JRPP Number	2011SYW060
Application Number	DA-946/2011
Proposed Development	Construction of a mixed commercial/residential development comprising two residential tower buildings containing 188 residential apartments, seven non-residential tenancies, three levels of basement car parking and associated landscaping and service facilities
Property Description	No. 2 Browne Parade, 1-3 Bigge St and 26-32 Hume Highway, Warwick Farm NSW 2170
Applicant	B.DE C.ENVIRONMENTAL PTY LTD
Land Owner	ESTMANCO PTY LTD
Capital Investment Value	\$39, 700, 000
Recommendation	Approval with Conditions

The Development Application was considered by the Joint Regional Planning Panel on 8 March 2012 where it was resolved to defer the determination of the application, and that the application be referred back to Council for further discussion on the issues raised by the panel.

This report provides a response to the issues raised by the Panel.

Figure 8: Numerically compliant side setback

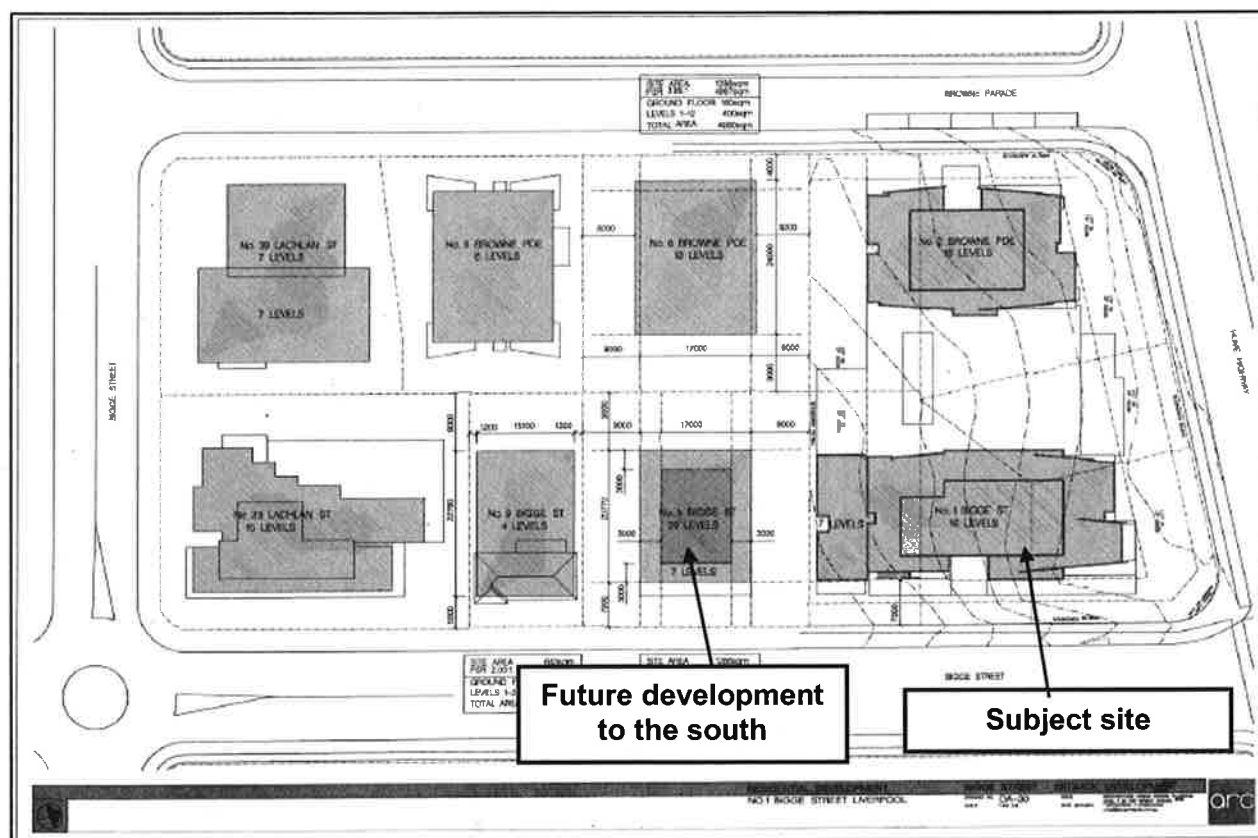
“There has been a significant departure from the development standard as prescribed in clause 7.4 of LEP 2008 requiring 9m separation between adjacent buildings that have a height of 12 to 25 metres above natural ground level when applied on the basis of distributing the required setback distances equally between two adjoining properties.”

The figures (figure 8 and 9) provided below offer a visual concept of the outcome of a development that is numerically compliant and non-compliant with the setback requirements of the LEP for both the subject site and adjoining property to the south. An apparent distinction between a compliant development and non-compliance development can be made from these plans, which suggests that a numerically compliant development would have a detrimental impact on the visual amenity of the area including, the isolation of small unusable parcels of land between buildings and a non continuous street wall which will present poorly to the street.

Despite the numerical variation presented, it is considered that the proposed development satisfies the objectives of this clause, which are to ensure minimum sufficient separation of buildings for the reasons of visual appearance, privacy and solar access. A thorough assessment of the proposed development against each of these objectives is provided below:

The proposed development will contribute positively to the immediate and wider locality with respect to visual appearance. It is considered that the southern elevation of the development has been designed to increase the visual amenity of the development whilst reducing any potentially significant adverse impacts to neighbouring properties. Particular enhancements to the design of the southern boundary have been made in response to initial concerns raised by both the Design Jury and the Design Review Panel. The enhancements to the southern boundary include the tapering and narrowing at the ends of the two towers to reduce the visual impact of the development when viewed from the north and the south.

Figure 10: Shadow diagram

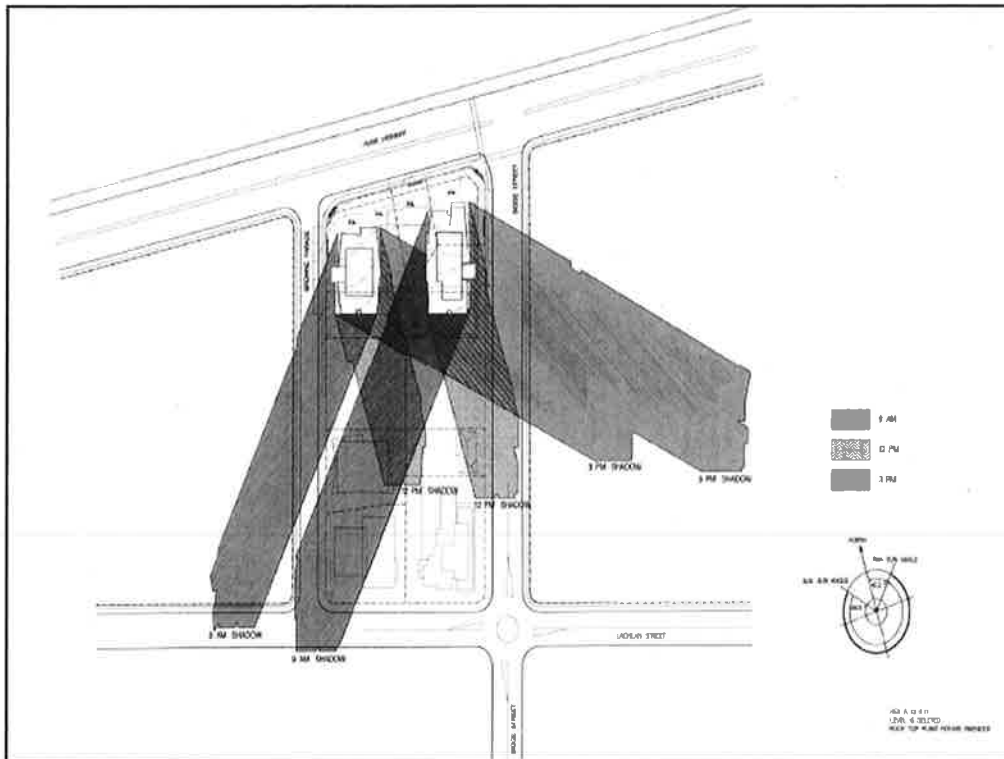
It is considered that the variation to the southern side setback will not result in an unreasonable amount of overshadowing to the adjoining property given that any future development on this site will most likely duplicate the design of the proposed development with respect to the east-west orientation of residential units as the site is able to facilitate this due to the provision of dual street frontages along Bigge Street and Browne Parade. In this regard, assessment of the below shadow diagrams (see figure 8) are based on the likely east-west orientation of any future development on this site. The shadow diagrams illustrate that the south-eastern aspect of adjoining site is overshadowed between 9am and 12pm with sunlight provided to this portion of the site in the afternoon hours on the winter solstice; whilst the south-westerly aspect of the adjoining site is overshadowed between 12pm and 3pm with sunlight provided to this portion of the site in the morning hours on the winter solstice.

The proposal will not result in unreasonable solar impacts to any future adjoining development
